Planning and Zoning Commission

March 2, 2021

RE: South James Plat 1 Preliminary Plat

RE: Christian Brothers Auto Site Plan

LOT LAYOUT PLAN

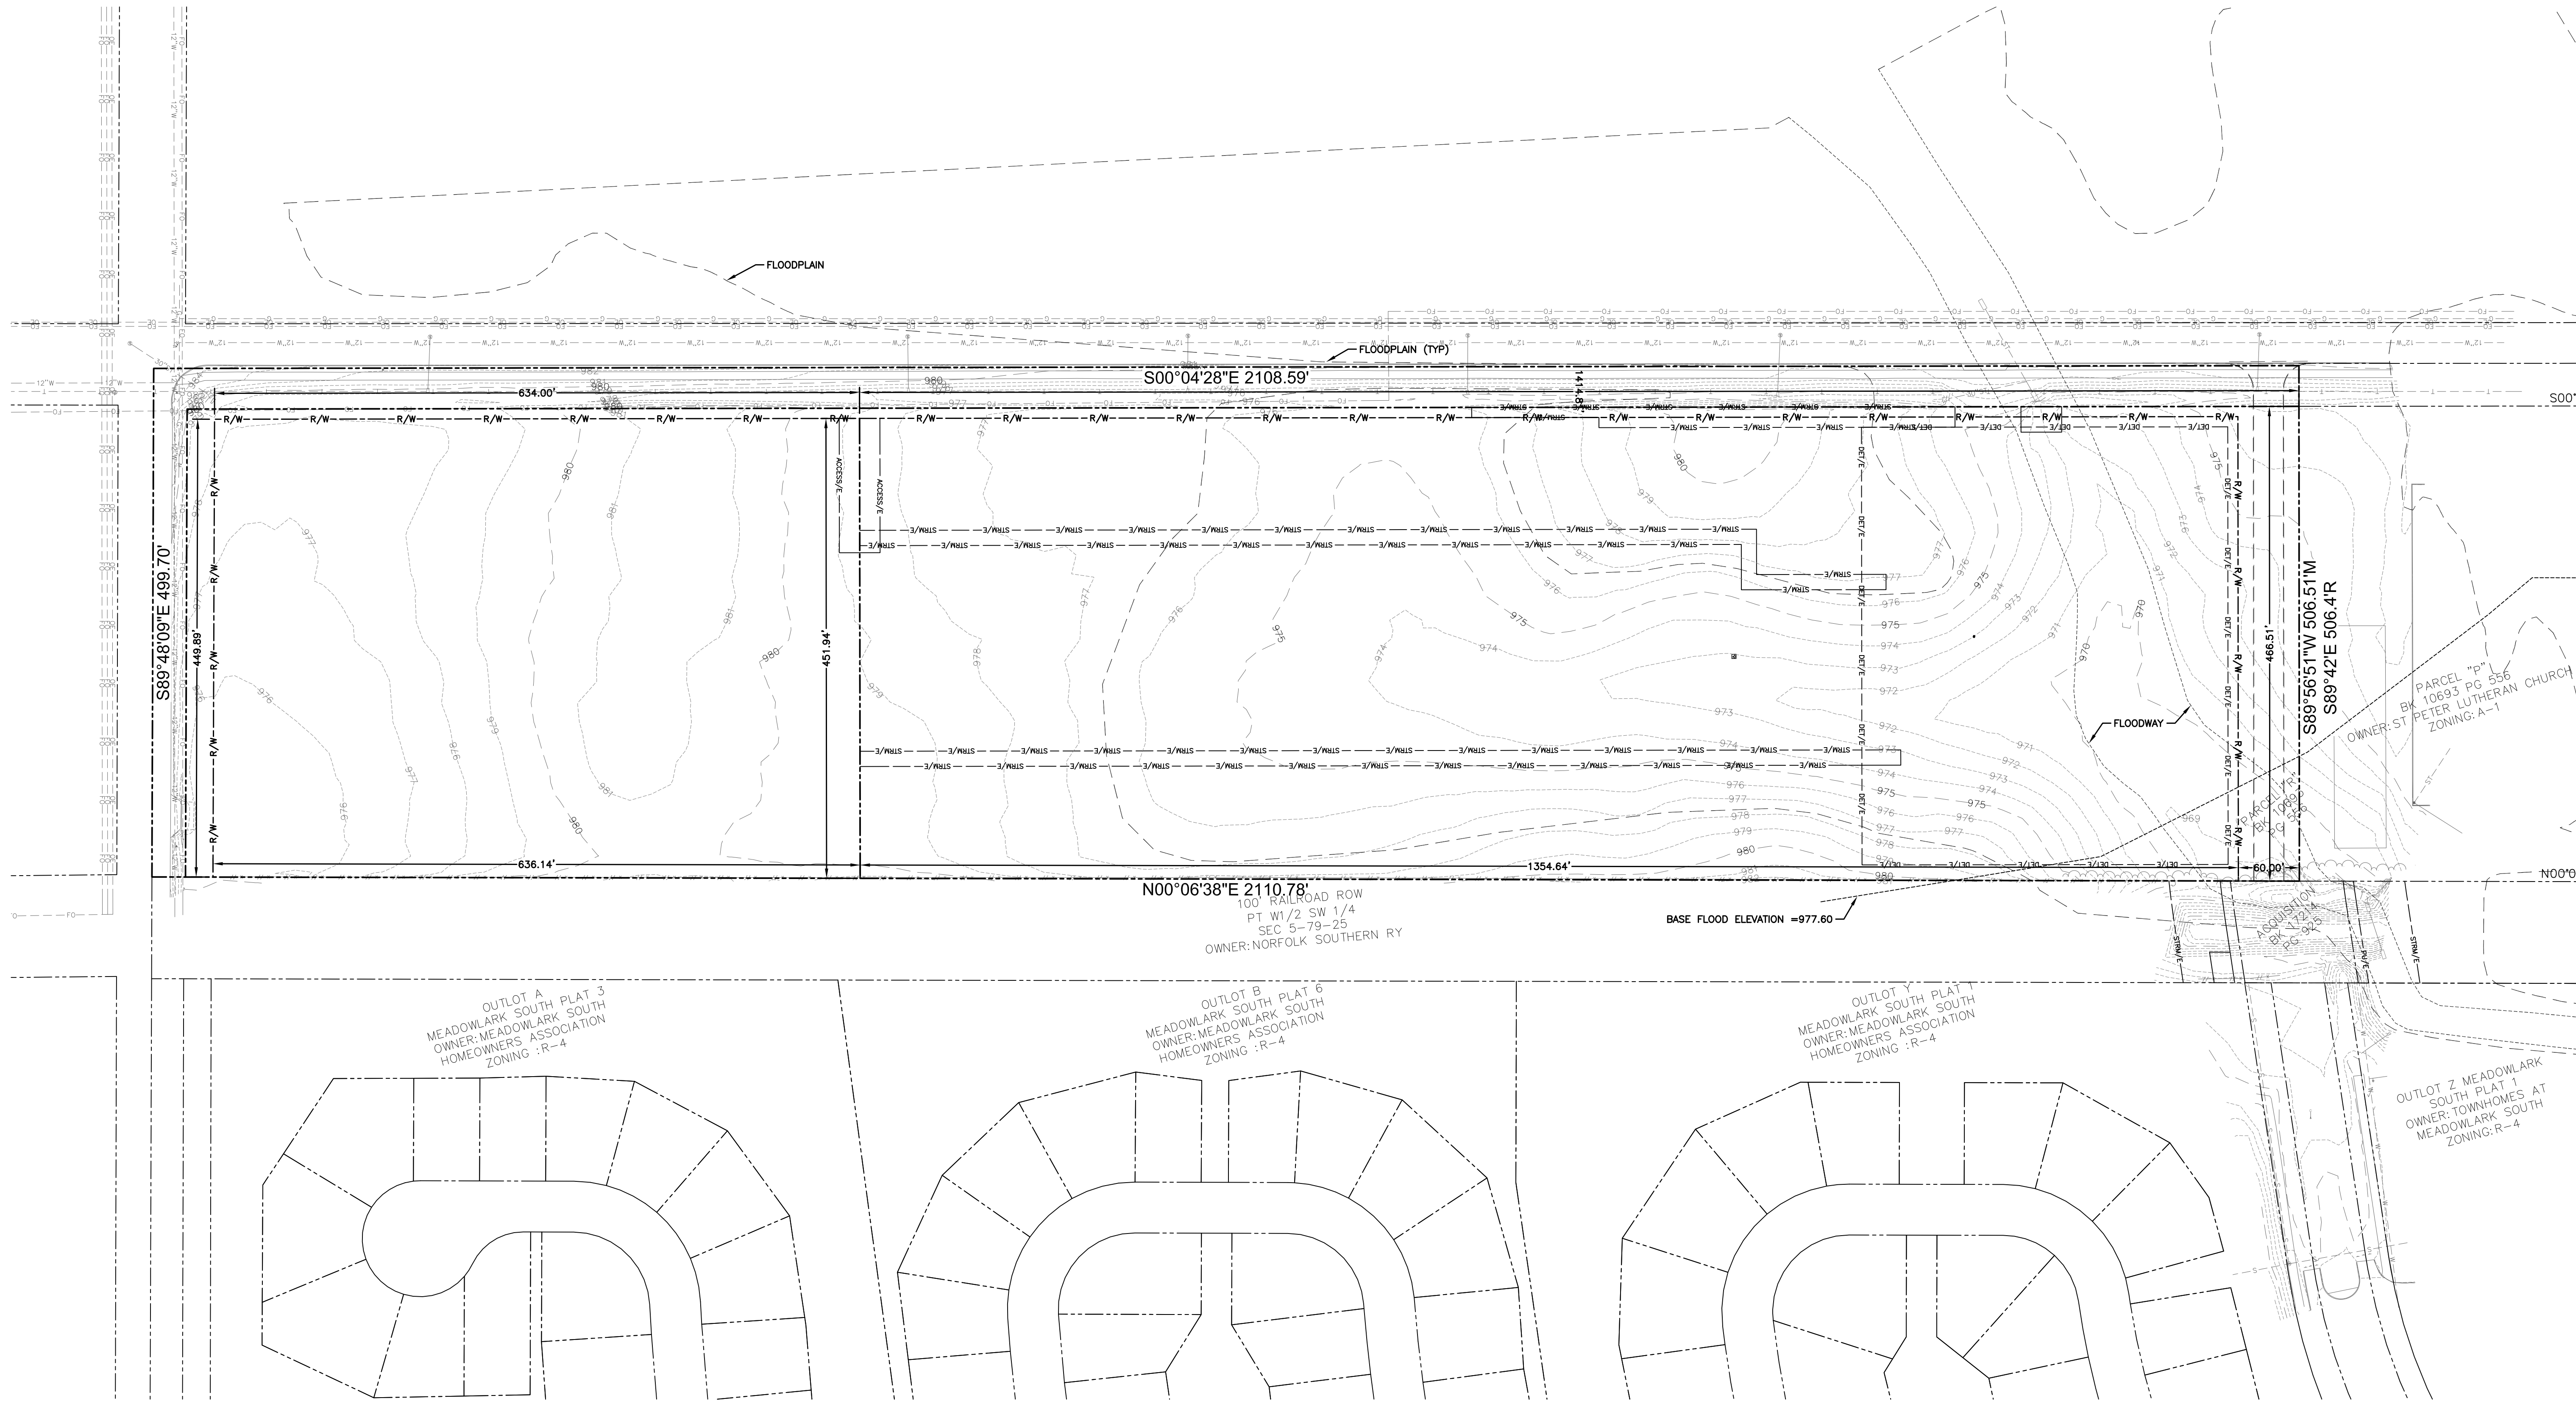
- ~~1. Update the bulk regulations section to say "See South James Development Agreement." Bulk regulations on the plat do not match the development agreement. Once the development agreement is finalized, please update the standards.~~
- ~~2. Add open space and parking setbacks to coversheet.~~
- ~~3. Add plat names and reference numbers to adjacent properties.~~
- ~~4. Add transportation Mixed Use Development Corridor District Overlay to the zoning~~
- ~~5. Add floodplain boundary.~~
- ~~6. Add floodplain designation. Where was this added?~~
- ~~7. Add base flood elevation.~~
- ~~8. Please provide sheets showing the plat without the development concepts. Please remove the townhome lots on Sheet C3.1.~~
- ~~9. Provide lot dimensions.~~

DIMENSION PLAN

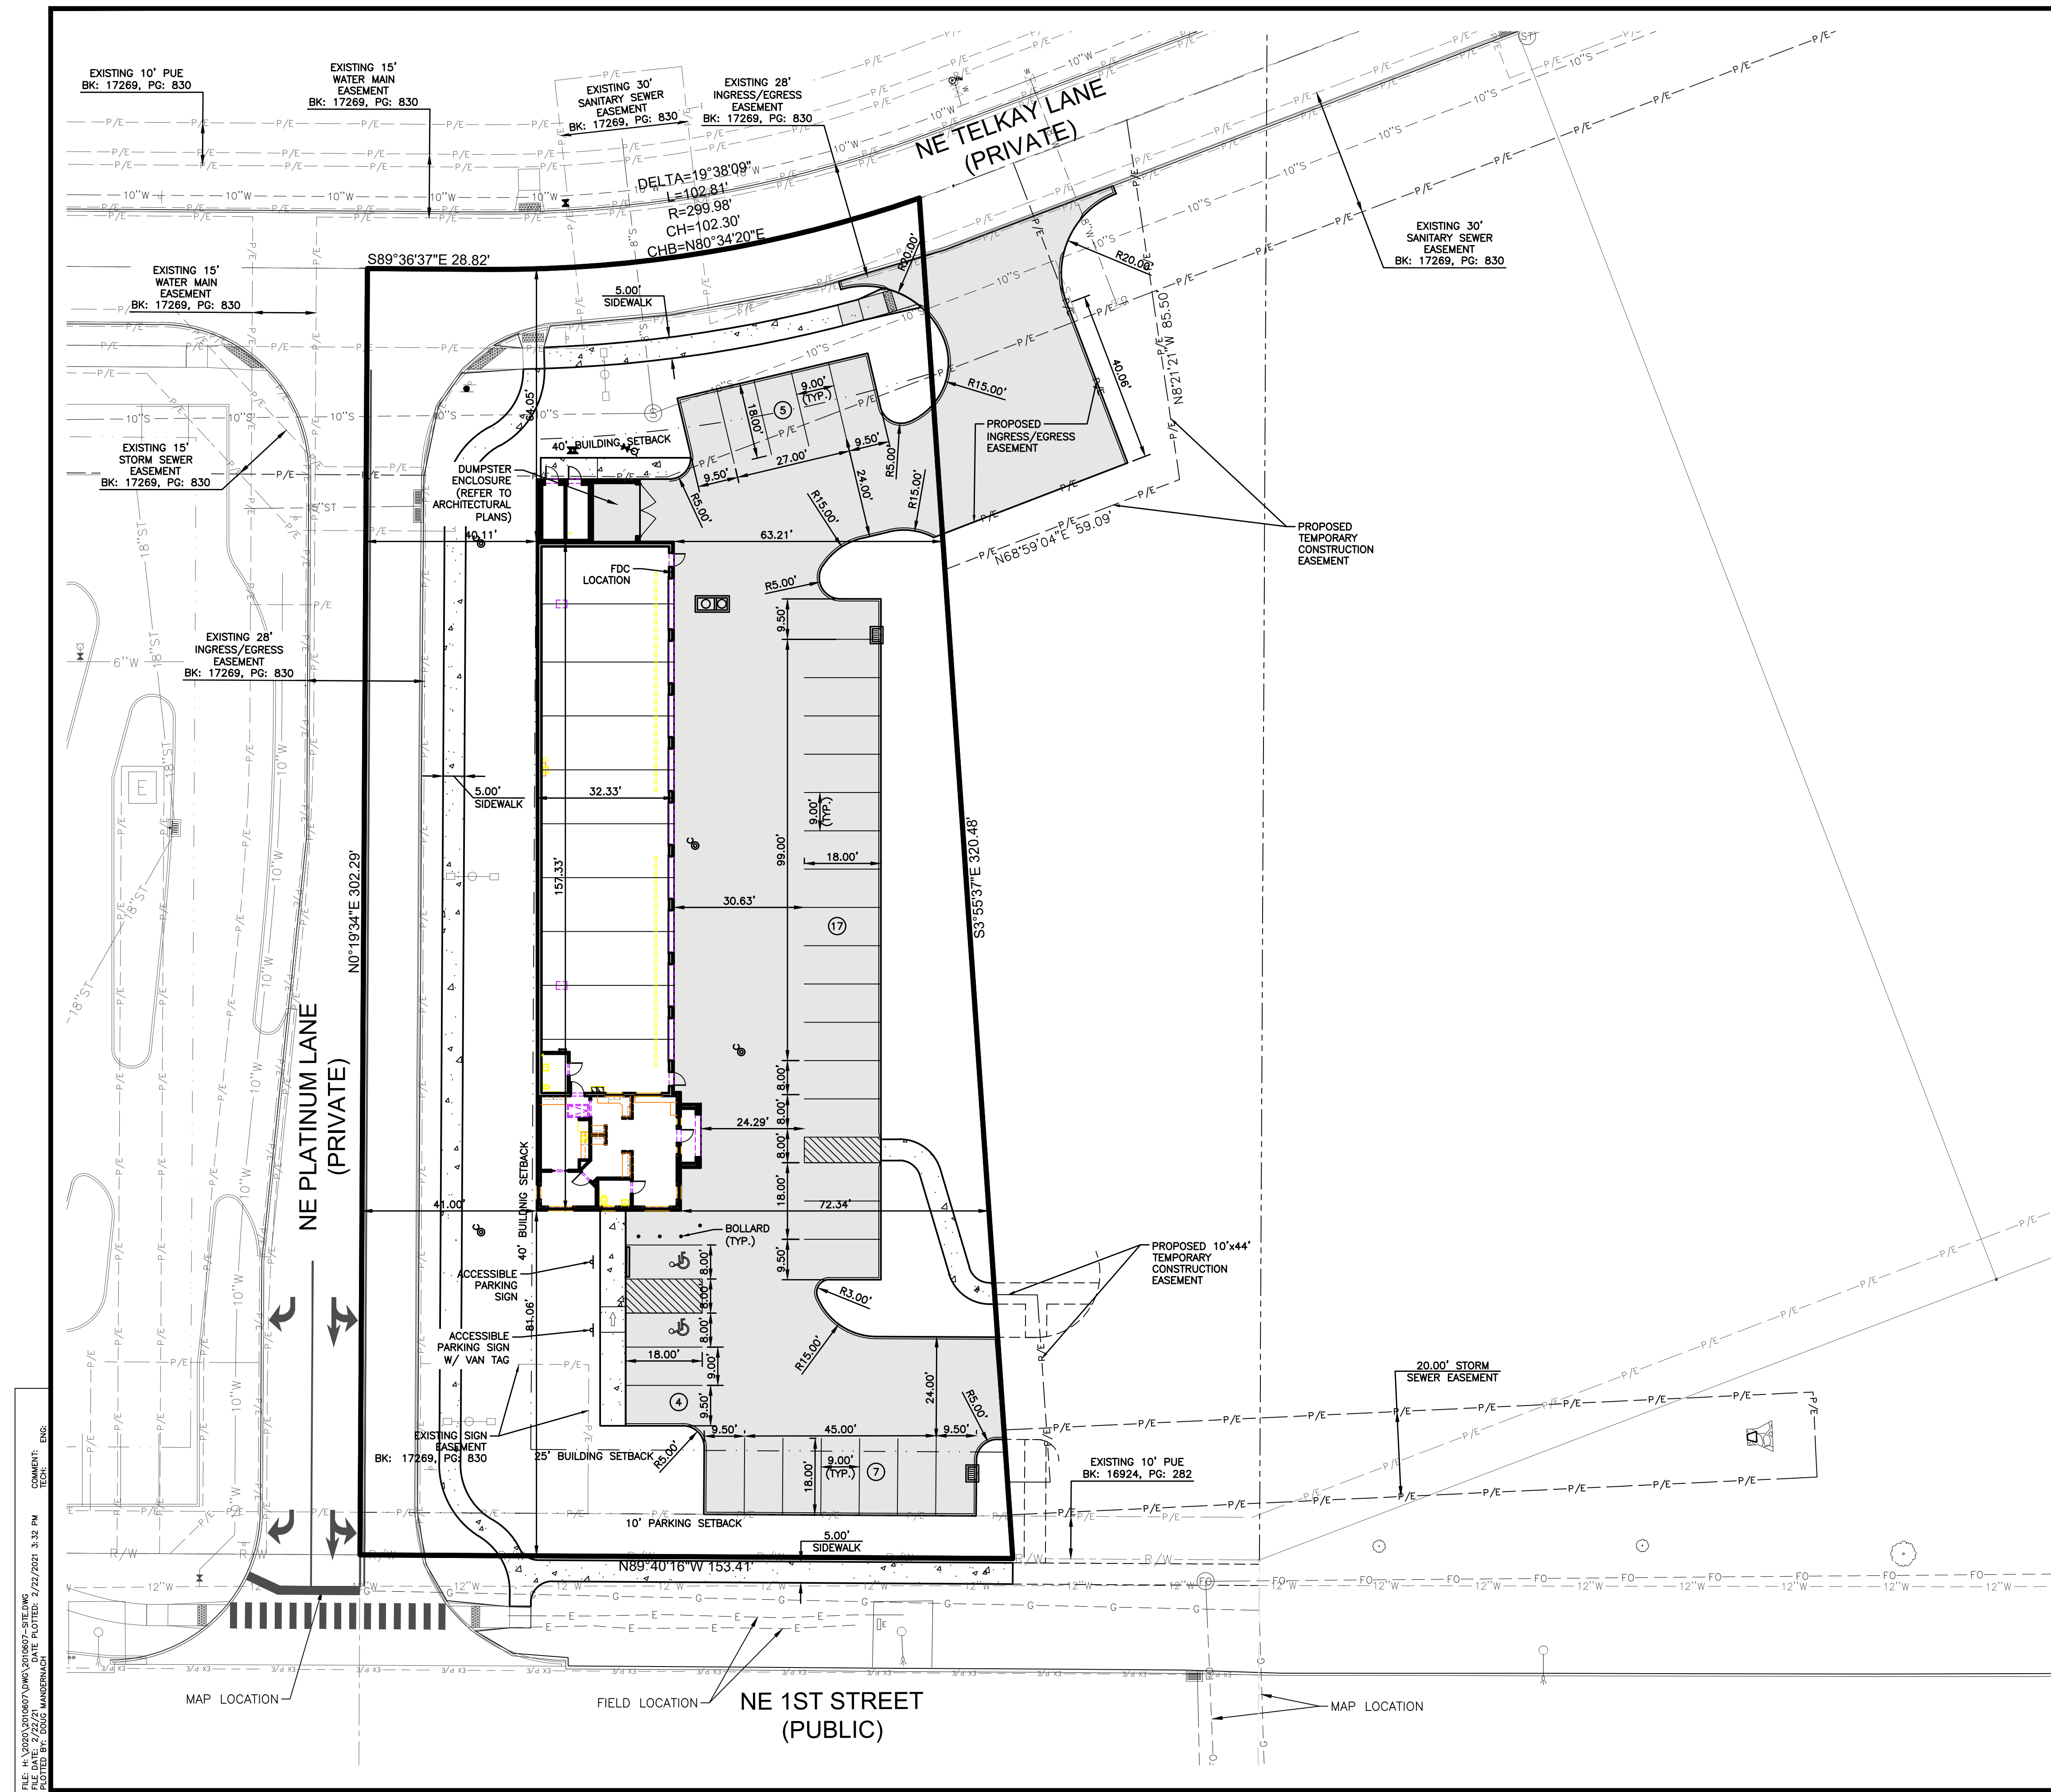
- ~~2. Show location of ADA signage.~~
- ~~3. Move parking on the south side of the building slightly to the west to maintain the same drive aisle width.~~
- ~~4. Are light poles proposed for the parking lot? If so, please add locations to the site plan and provide lighting details and pole heights. Provide a photometric plan.~~
- ~~5. Move handicap parking spaces south of the building to be closer and more protected from traffic.~~
- ~~6. Label the setbacks of the building foundation from all property lines.~~
- ~~7. Provide 150' hydrant coverage and FDC within 100' of a hydrant.~~
